# Rezoning Transportation Analysis

Petition Number: 2020-017

General Location Identifier: Tax ID 11101102

Date	Description
03-18-20	First Review
04-20-20	Second Review

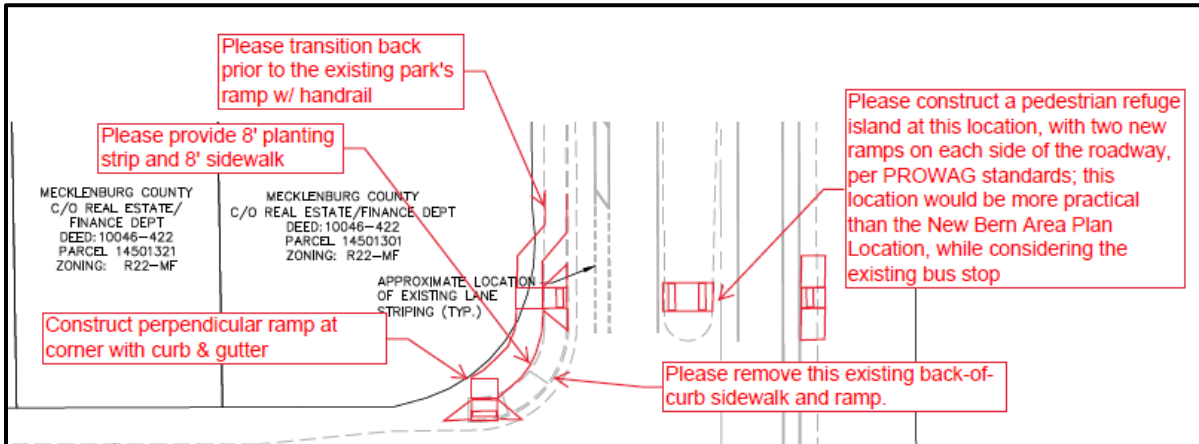
4. ~~Resolved~~ We request the petitioner to revise the site plan and conditional note(s) to construct a pedestrian refuge island across Remount Road, in reference to the Vision Zero Action Plan and enhanced intersection crossing included within the New Bern Area Plan. CDOT has notified Mecklenburg County of the possibility of the petitioner possibly attaining public utility and construction easements to improve the streetscape at this intersection. Please contact Jacqueline McNeil at ([Jacqueline.McNeil@mecklenburgcountync.gov](mailto:Jacqueline.McNeil@mecklenburgcountync.gov)) or (980-314-2511) and Bert Lynn at ([Bert.Lynn@mecklenburgcountync.gov](mailto:Bert.Lynn@mecklenburgcountync.gov)) or (704-589-7491). The pedestrian refuge may be unsignalized, but should still include MUTCD pedestrian crossing signage with a marked crosswalk. Please provide CDOT with an exhibit to review.

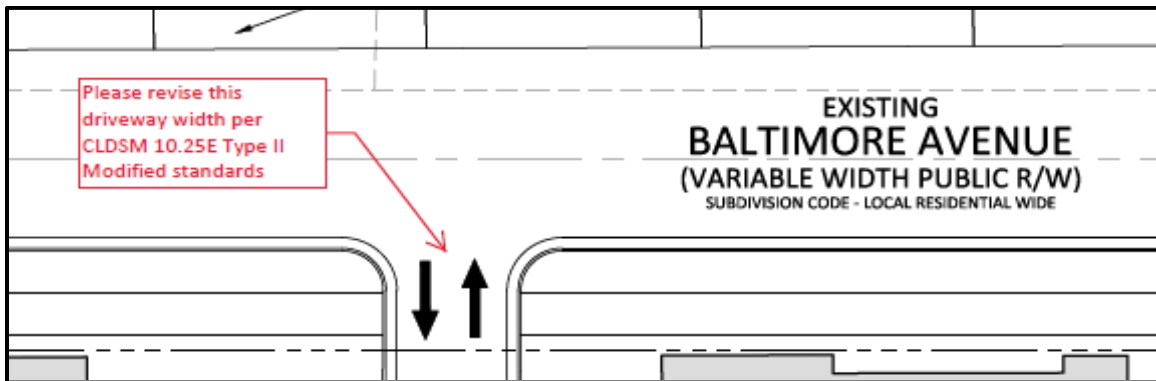
5. ~~Resolved~~ The petitioner is required to revise the site plan and conditional note(s) to widen the proposed access on Baltimore Avenue to a CLDSM standard for two-way traffic.

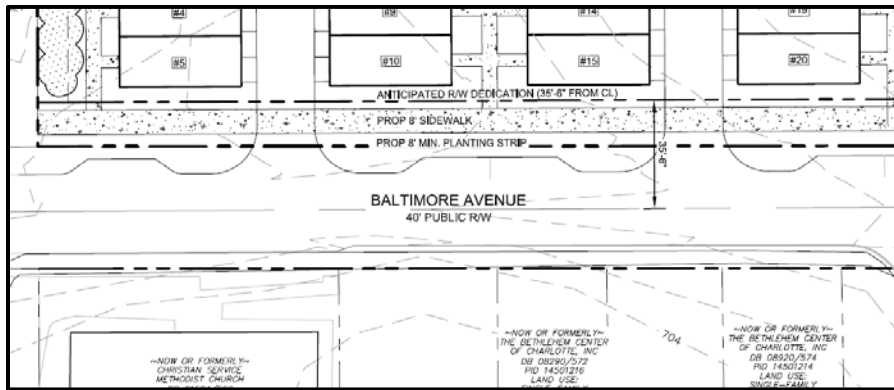
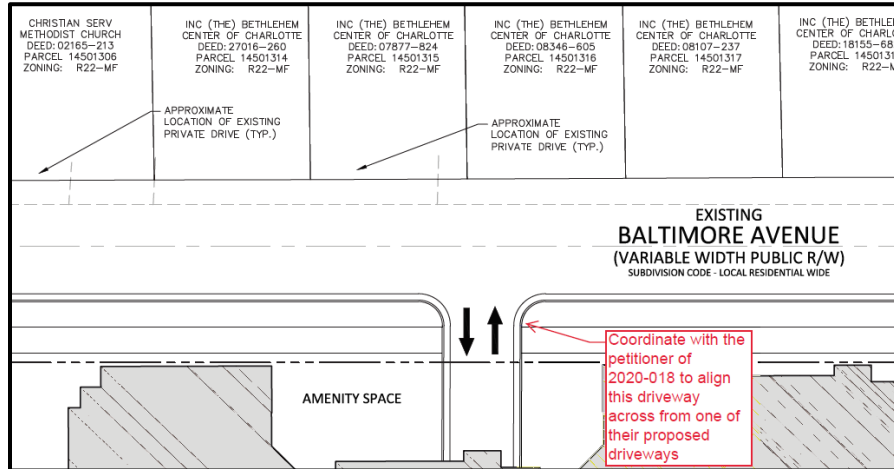
6. ~~Rescinded, adequate driveway spacing is provided. The petitioner is required to revise the site plan and conditional note(s) to coordinate with the petitioner of 2020-018 to align the proposed access with one of the two proposed driveways with within rezoning petition 2020-018's proposed site plan, or vice-versa.~~

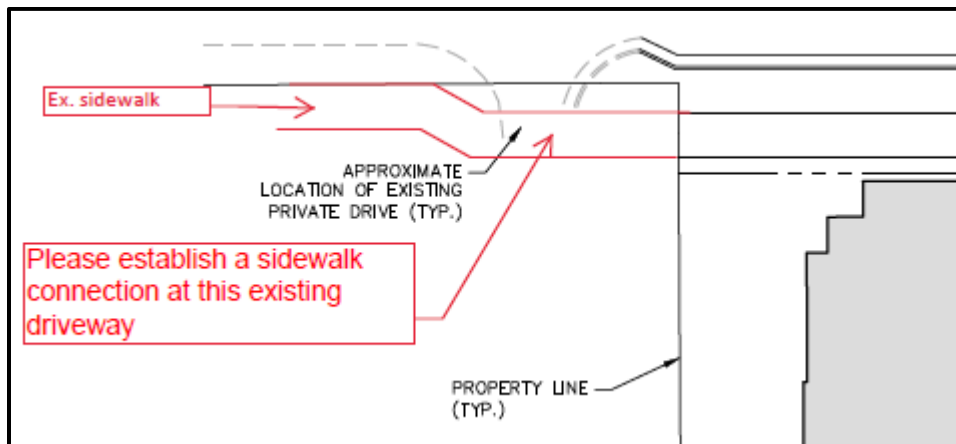
7. ~~Rescinded In reference to the Charlotte WALKS adopted plan, the petitioner should revise the site and plan and conditional note(s) to replace the existing driveway to a CLDSM standard, to the extent possible within the public right of way, to properly connect the proposed sidewalk into the existing sidewalk to improve accessibility.~~

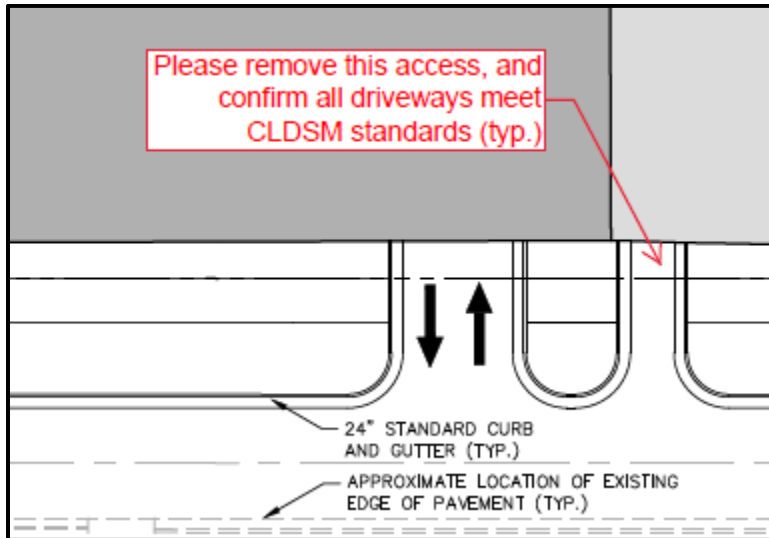
8. **Resolved** The petitioner should revise the site plan and conditional note (Section IV. Transportations, 3) to add specify dedication and fee simple conveyance of **all** rights of way to the City before the site's first building certificate of occupancy is issued. CDOT requests right of way set at 2' behind back of sidewalk where feasible.
9. **Resolved** The petitioner should revise the site plan and conditional note(s) to remove the proposed access on Norfolk Avenue, as shown below.

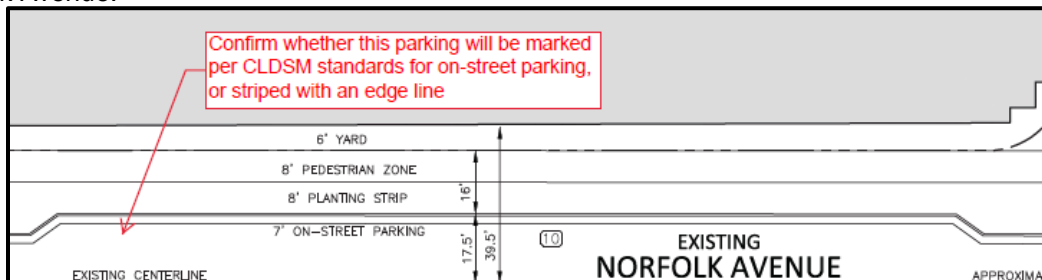
10. **Resolved** The petitioner should revise the site plan and conditional note(s) to clarify if the Norfolk Avenue on-street parking will be used to count toward Zoning Ordinance parking requirements. If so, one accessible on-street parking space will be required, affecting the proposed streetscape along Norfolk Avenue.

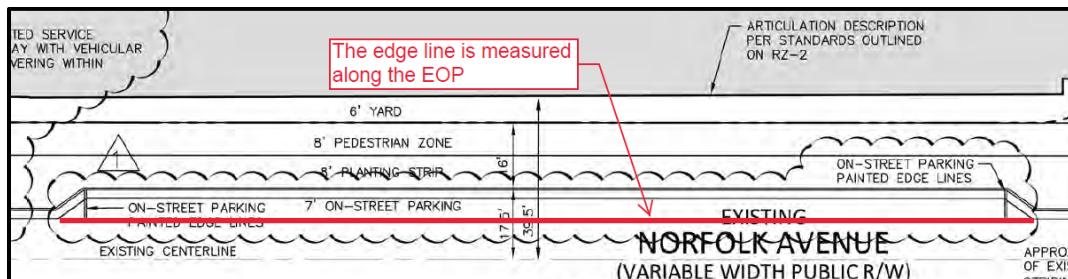
- a. **Technical Clarification** The petitioner should revise the site plan to show the edge line measured parallel to the edge of pavement and curb line.
